Docket Item # 2
BAR CASE # 2009-0197

BAR Meeting
September 23, 2009

ISSUE: After-the-fact approval of alterations to previously approved plans
APPLICANT: James and DeShuna Spencer
LOCATION: 229 North West Street
ZONE: RB/Residential

Figure 3. Previously approved east elevation.

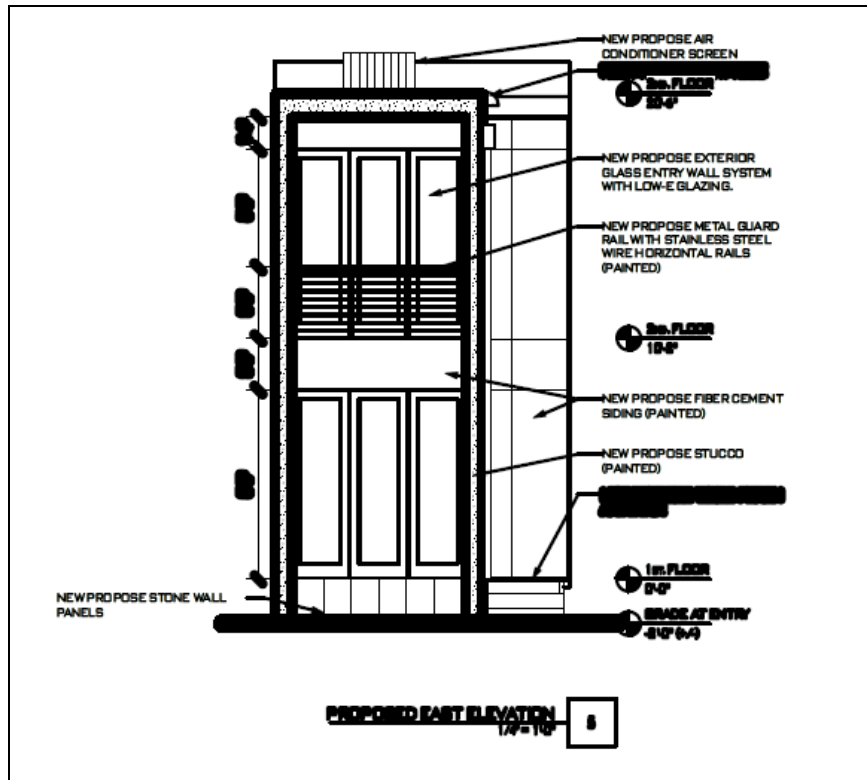
- Installation of six inch exposed face fiber cement siding on the rear (east) elevation instead of the approved fiber cement panels;
- Installation of 18 inch by 72 inch fiber cement panels on the rear (east) elevation instead of the approved stucco;
- Installation of a wood slat railing at the rear second story instead of the approved metal railing;
- Installation of new wood slat door (eight feet) at the horse alley on the rear (east) elevation;
- Installation of a wood rear deck at first story of rear (east) elevation; and,
- Removal of approximately 120 square feet of historic siding on the front (west) elevation without Staff approval as approved by the BAR approved conditions.

Thus, Staff finds the use of fiber cement on the new addition is in conformance with the Board's policy. As the Board had previously approved stucco and fiber cement siding and panels on the addition, Staff finds the changes to different forms and sizes of fiber cement to be acceptable.

Figure 4. Previously proposed west elevation for BAR Case # 2008-0149 (Paired window on second floor not approved).

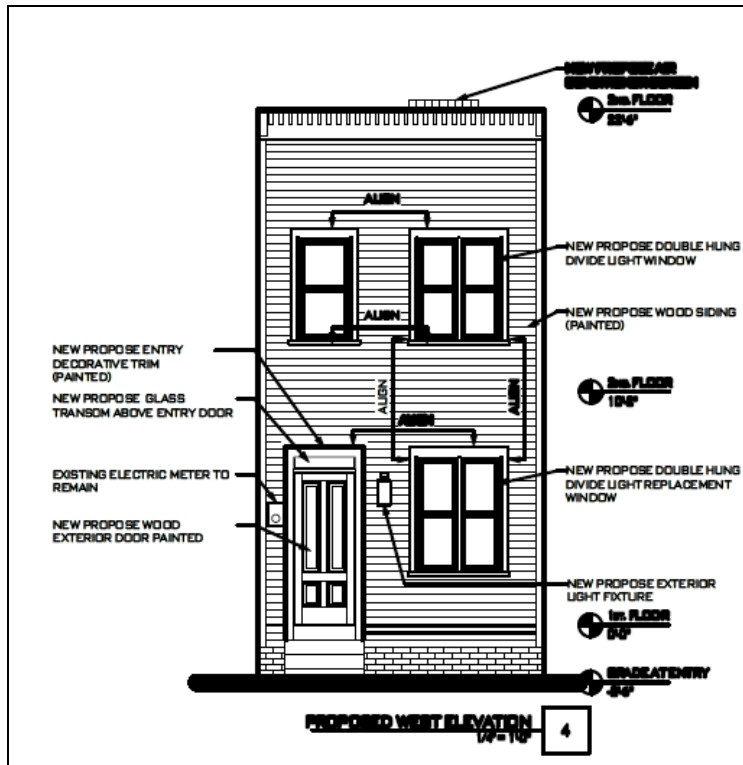
The alteration that most concerns Staff is the removal of historic wood siding on the front (west) elevation. As part of the approval process, the Board made the following conditions:

- That the applicant work with Staff to evaluate any historic wood siding underneath the aluminum siding on the front elevation and determine whether it can be retained and repaired; and,
- That if the condition of the siding is poor, the applicant should install the same type of wood siding that was originally on the house.

The applicant contacted Staff to evaluate the condition of the wood siding underneath the aluminum siding. While a small portion of the siding was in poor condition and in need of an in-kind replacement, Staff determined that the majority of the siding was in sufficient condition that it should be repaired and retained, rather than replaced. Despite Staff's determination, the applicant proceeded to remove and replace all of the historic wood siding. Obviously, this is of grave concern to Staff as the removal of historic fabric compromises the historic integrity of the building and the district, as well as undermines the Board's efforts and intentions in the review and approval process. Further, the zoning ordinance and *Design Guidelines* explicitly state that historic materials should be retained and repaired rather than replaced. In addition, the zoning ordinance levies fines for civil violations of the zoning ordinance related to historic districts. In this circumstance,

Figure 8. Revised north elevation.

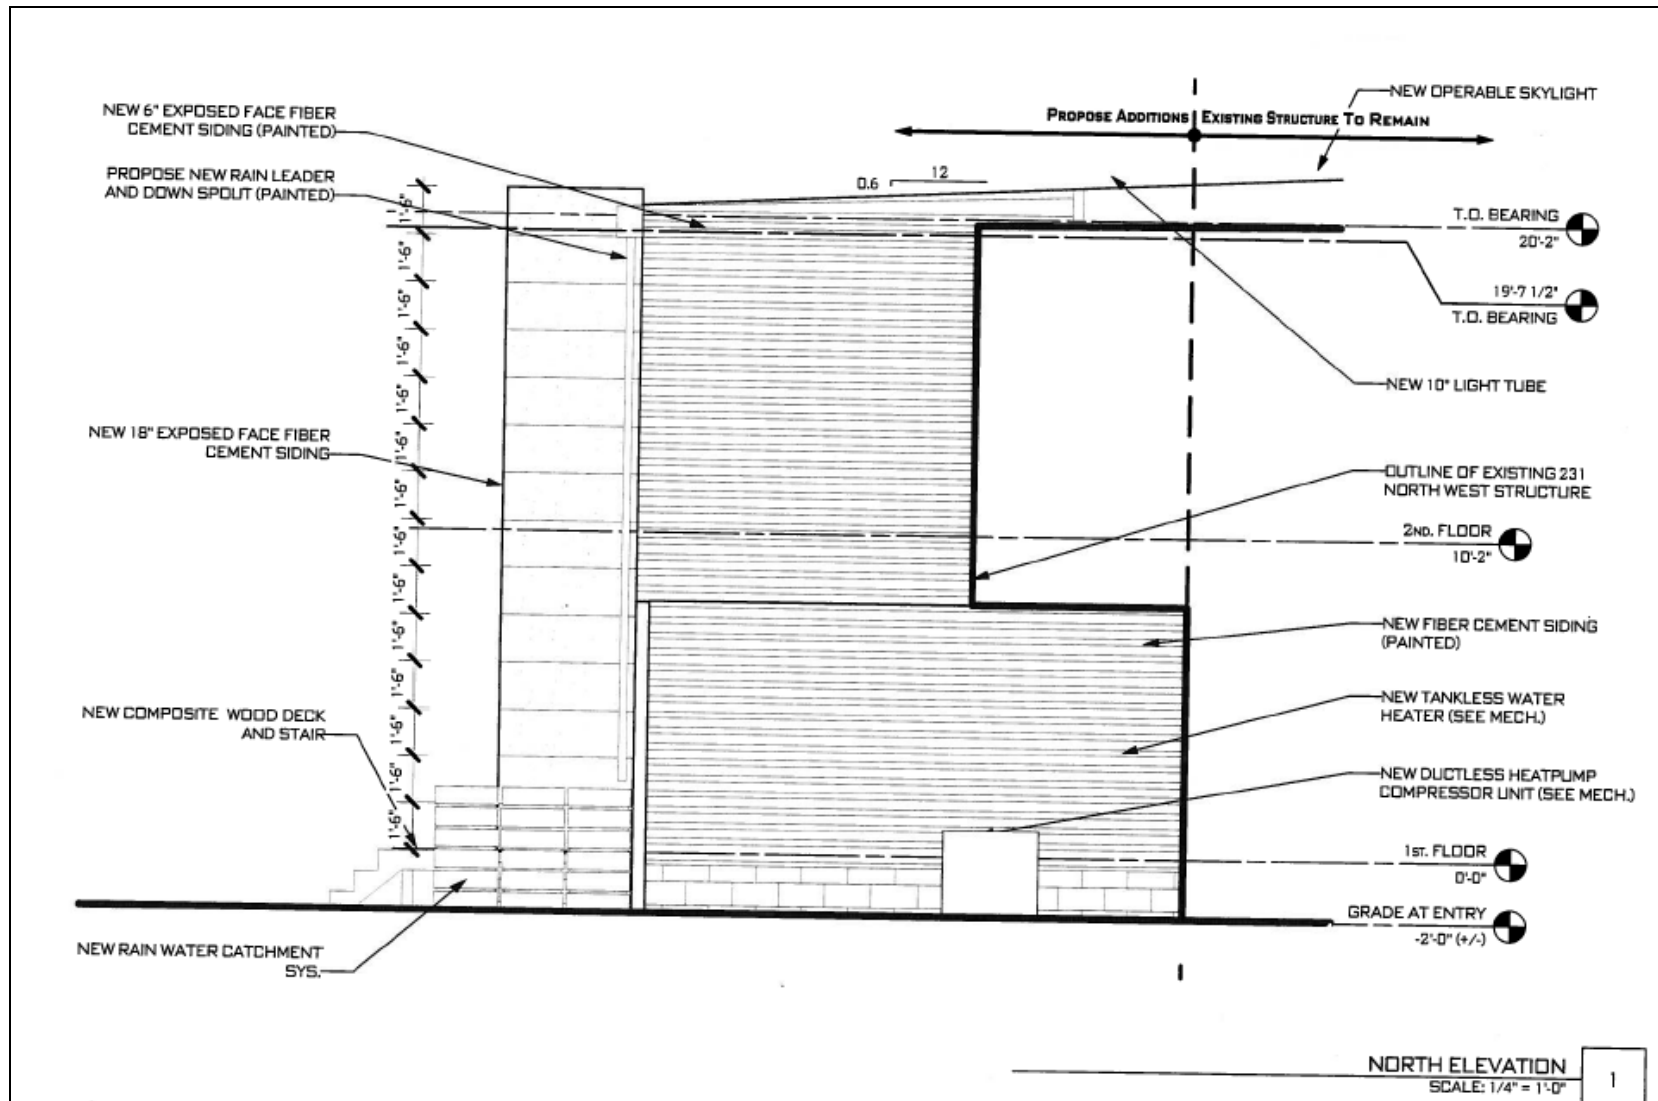
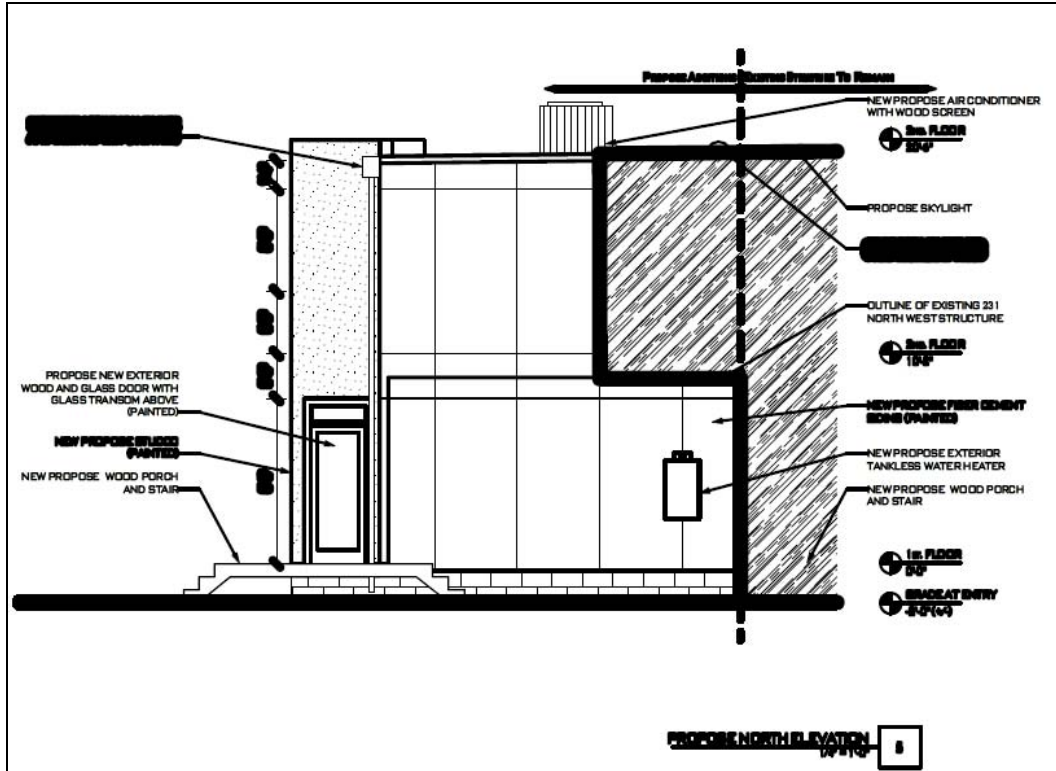
The choice of a wood railing in place of metal on the second story rear elevation is appropriate and consistent with the *Design Guidelines*. The proposed wood deck is an appropriate design and material and will not be visible from the public right-of-way once the rear yard fence is installed.

Figure 9. Revised south elevation.

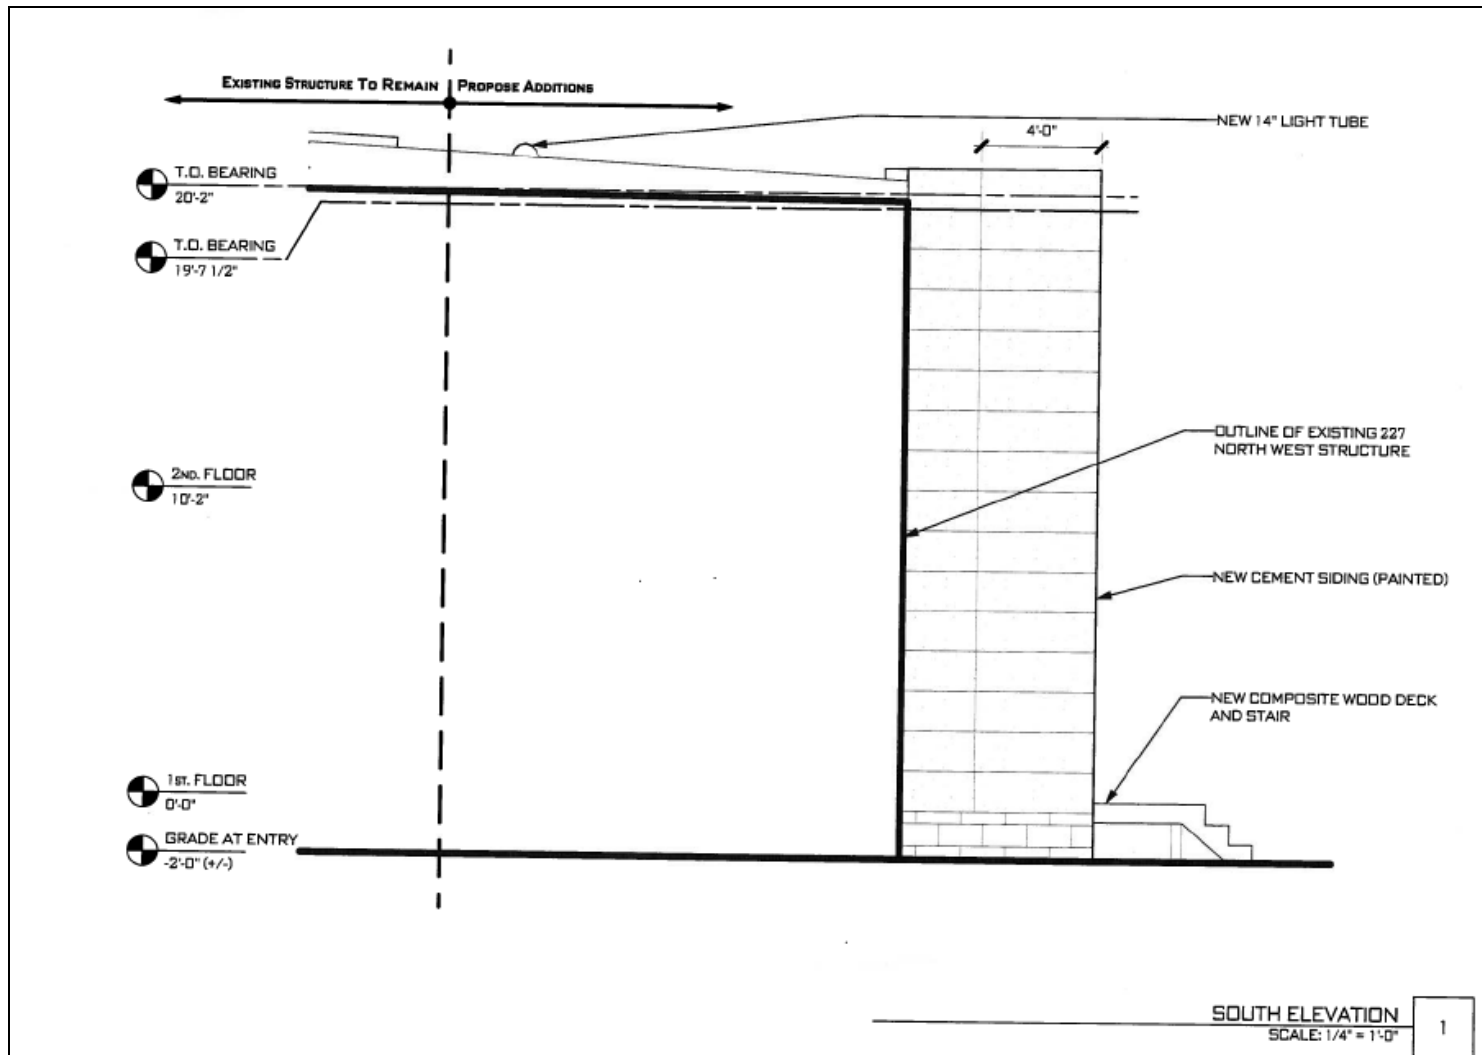
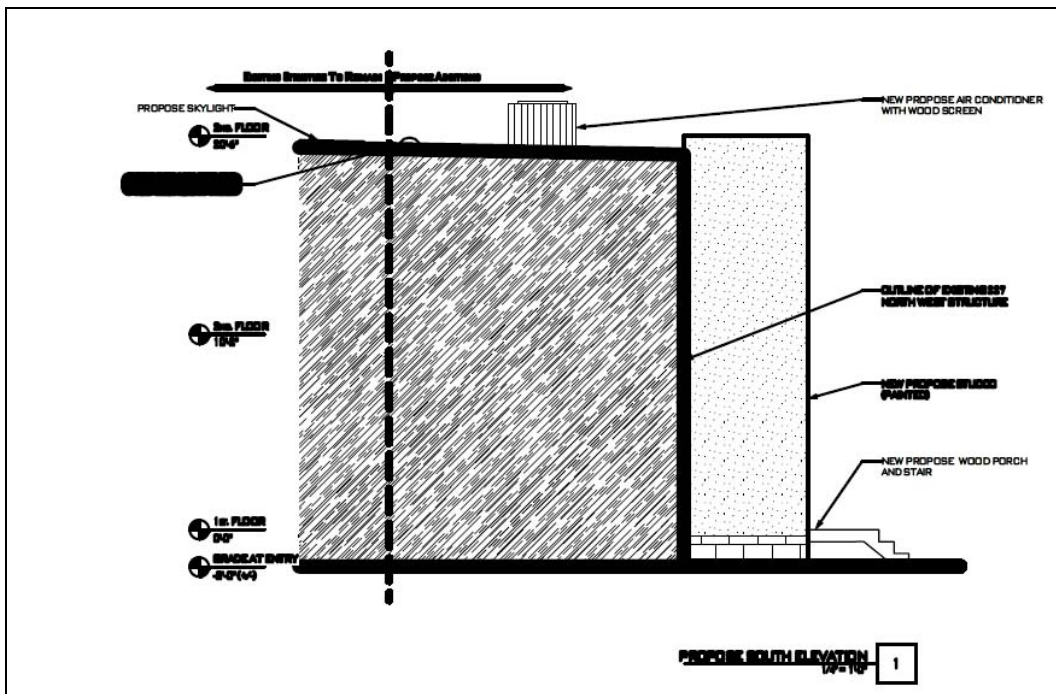
While the proposed rear gate with horizontal wood slats has a contemporary style, Staff finds that it is consistent with the approved contemporary addition and makes use of a traditional building material. Furthermore, the gate will be minimally visible from the public right-of-way.
